Re: Indian Point Unit No. 3
Docket No. 50-286
NL-03-140

Subject: **Reply to Request for Additional Information
Regarding NRC Order EA-03-009 Relaxation Request (TAC MB8163)**

**RESPONSE TO NRC QUESTIONS REGARDING
NRC ORDER EA-03-009 RELAXATION REQUEST
PERTAINING TO INSPECTION OF THREADED REGION OF NOZZLES**

**NRC ORDER EA-03-009 RELAXATION REQUEST, REVISION 1
PERTAINING TO INSPECTION OF THREADED REGION OF NOZZLES**

FIGURE 1
 IP3 PENETRATION NOZZLES
 HEAD NOZZLE WELD AREA

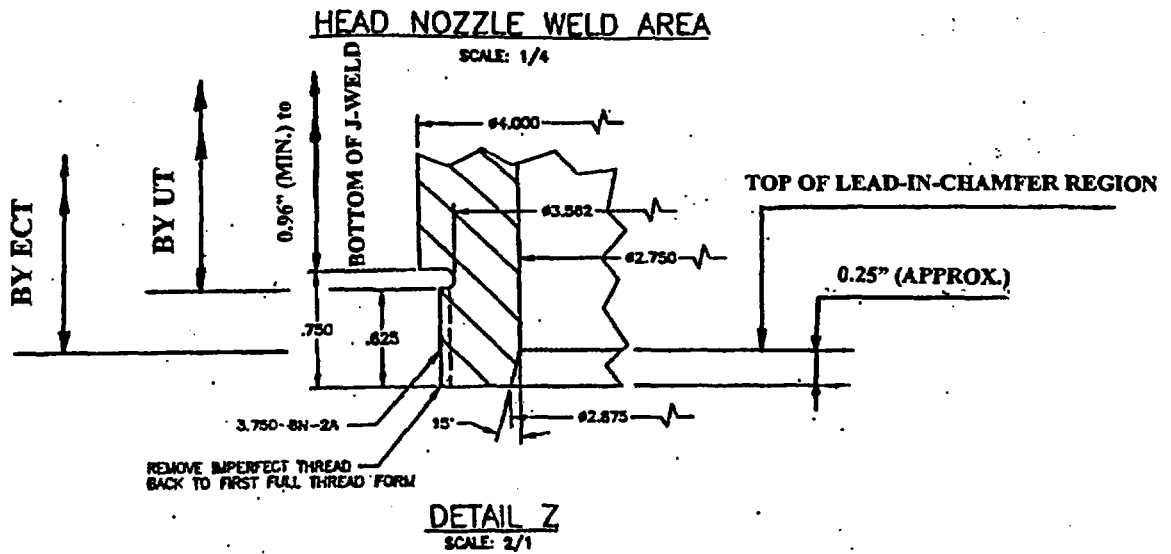
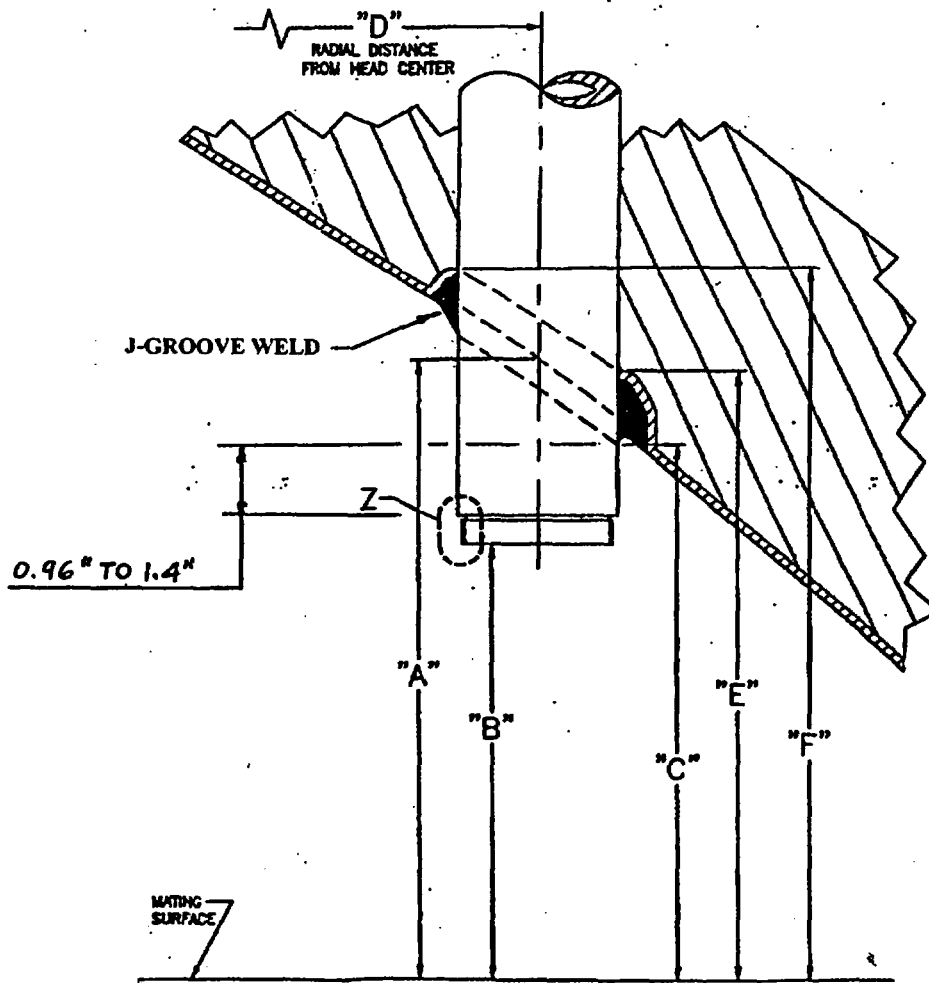
The licensee stated that a structural evaluation was performed for the IP3 nozzles.

Provide the applicable technical data (i.e., operating stress levels, crack growth analysis, hoop stresses, etc) which supports the conclusion that the area in the threaded region is insignificant.

The structural evaluation for Indian Point 3 consists of a crack growth analysis using the methods of MRP-55 for crack growth caused by primary water stress corrosion cracking at a head temperature of 592 degrees F. The nozzle is an open-ended tube so that the operating pressure and temperature are essentially the same at both the inside and outside surface of the tube. Therefore the operating stress levels are negligible for this case. For purposes of this analysis, a conservatively high hoop stress of 30 ksi is assumed. An initial hypothetical flaw is assumed to exist with a worst-case orientation (axial) and flaw growth occurs in a single direction toward the J-groove weld. Because the location of the hypothetical flaw is in the threaded region, at least 0.96 inches from the J-groove weld, the weld residual stresses are also negligible. The analysis concludes that crack growth in a 4-year operating period is approximately 0.54 inches, well within the minimum dimension of 0.96 inches to the closest point of the J-groove weld. Refer to Figure 1 in the relaxation request for the location of these dimensions on the penetration nozzles.

case, non-destructive examination of the RPV head penetration nozzles is required by the Order. However, the bottom 0.75 inches of the nozzles are designed with a threaded region to accommodate the installation of guide funnels (Figure 1). Based on experience gained during the inspection in 3R12, meaningful ultrasonic test data cannot be obtained in this region, due to dispersion of the ultrasonic test signal. Therefore, the relaxation request is needed to support a non-destructive examination of the RPV nozzles based on use of ultrasonic test methods.

The ultrasonic testing will extend from two (2) inches above the J-groove weld to the top of the threaded region at the bottom of the penetration nozzle. The axial dimension from the bottom portion of the J-weld (at the lowest point) to the top of the threaded region ranges from 0.96 inches to 1.4 inches, depending on the radial location of the nozzle. This coverage provides an acceptable level of quality and safety because:

- A conservative analysis for the IP3 nozzles shows that the crack growth over a 4-year operating period would be approximately 0.54 inches. An undetected crack at the most limiting location (at the top end of the threaded region) would have to propagate 0.96 inches in the most limiting nozzles in order to reach the J-groove weld. Since the inspection frequency for IP3 would be at least every other refueling outage (nominally every 4 years) for a moderate category classification, an undetected crack in the threaded region would not propagate to the J-groove weld prior to the next inspection interval. The inspection program with a high category classification would require a more frequent inspection, every refueling outage.
